TECHNICAL BULLETIN

SU-15-08
21 April 2015

MODEL AFFECTED: UH-1H

SUBJECT: ALTERNATE SPARE PART; SWASHPLATE GIMBAL RING ASSEMBLY P/N 212-010-416-101

FIGURE 1

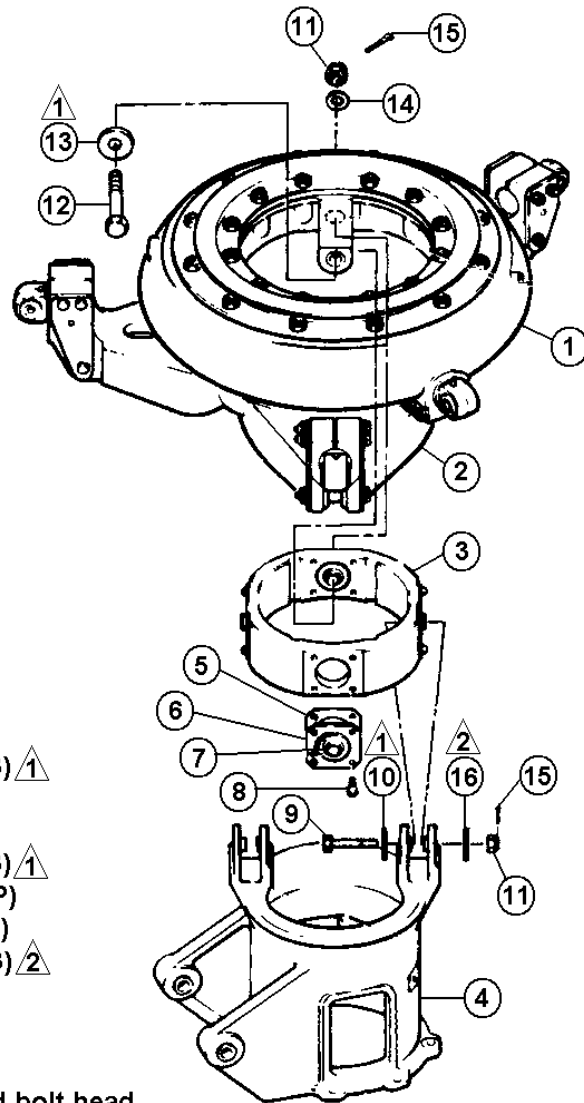
- a. Refer to Figure 1. Visually inspect all parts for serviceability or evidence of damage; repair and/or replace unserviceable parts as required. Parts noted on Figure 1 as **REPLACE** are to be replaced regardless of serviceability.

Refer to Figure 1, notes 1 and 2. Install P/N 204-011-457-003 Washer with chamfer toward bolt head and, when installed under nut, install with chamfer toward lug.

- 1. Outer Ring
- 2. Inner Ring
- 3. Gimbal Ring (212-010-416-101)
- 4. Support
- 5. Shim (212-010-418-101)
- 6. Bearing & Liner Assy (212-010-417-101)
- 7. Bearing (MS27640-5)
- 8. Bolt (NAS6203-1H)
- 9. Bolt (REPLACE with 204-011-463-003)
- 10. Washer (REPLACE with 204-011-457-003) ¹
- 11. Nut (REPLACE with MS14145L5)
- 12. Bolt (REPLACE with 204-011-463-001)
- 13. Washer (REPLACE with 204-011-457-003) ¹
- 14. Washer (REPLACE with NAS1149F0563P)
- 15. Cotter Pin (REPLACE with MS24665-155)
- 16. Washer (REPLACE with 204-011-457-003) ²

- ¹ Install washer with chamfer side toward bolt head.
- ² Install washer with chamfer side toward lug.
